W3F1-2021-0064

Subject: Proposed Revision to Reactor Vessel Surveillance Capsule Withdrawal Schedule to Support Relocation of Capsules 104° and 284°

Waterford Steam Electric Station, Unit 3
NRC Docket No. 50-382
Renewed Facility Operating License No. NPF-38

**Proposed Revision to Waterford 3
Surveillance Capsule Withdrawal Schedule**

Figure 1 Arrangement of Surveillance Capsules in the Waterford Unit 3 Reactor Vessel

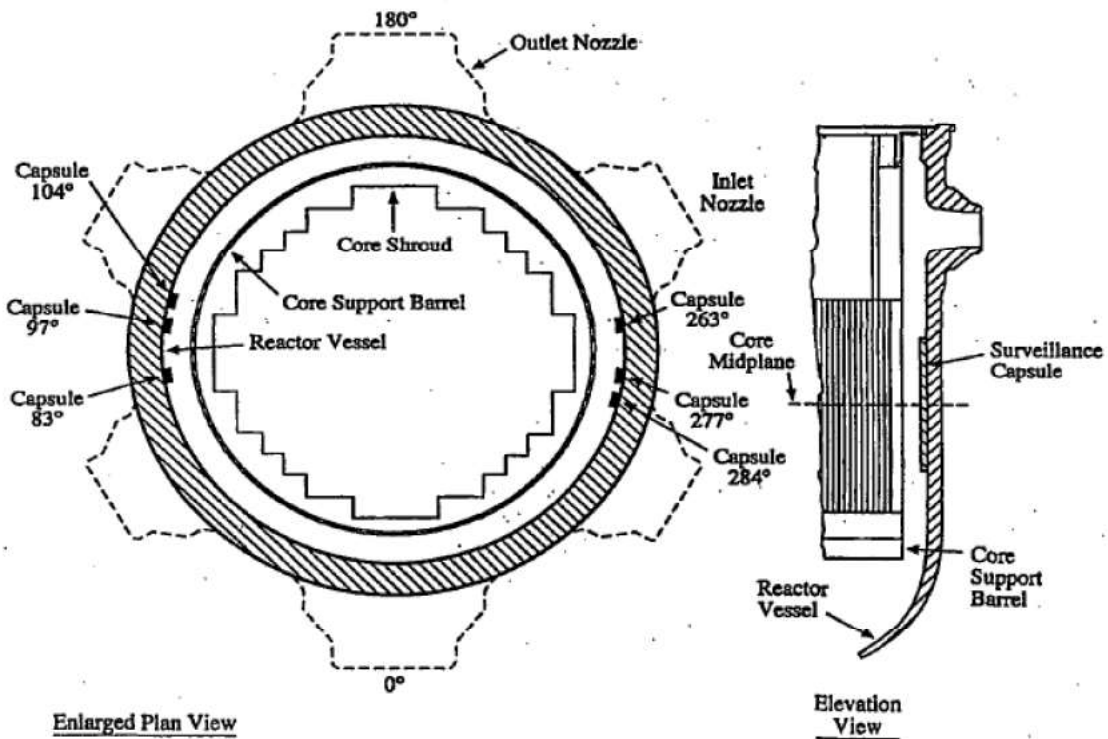
Waterford Unit 3 will relocate the surveillance capsules at 104° and 284° to the locations at 97° and 263°, respectively, during Refueling 24 outage. The objective of this relocation is to place surveillance capsules in a higher neutron flux location in order to have meaningful data in the future and support potential future license renewal periods.

As can be seen in Table 3 and Table 4, capsules residing at the 14° location of the octagonally symmetric model, which includes both Capsules 104° and 284°, will experience the lowest fluence rate of all capsule

locations, and, in fact, trail the peak fluence experienced by the RV wall. All vacant locations, which are located at a 7° location of the octagonally symmetric model, experience the same higher fluence rate. Therefore, the location closest to the current location was chosen as the destination for the relocated capsules.

In order to account for potential issues with relocating the capsules, contingency plans are proposed in this section. As stated above, all vacant locations, which are each located at a 7°-equivalent location, experience the same fluence rate. Therefore, if either the 97° or 263° vacant locations are unable to be utilized, the vacant 83° location provides an acceptable and radiologically equivalent alternative.
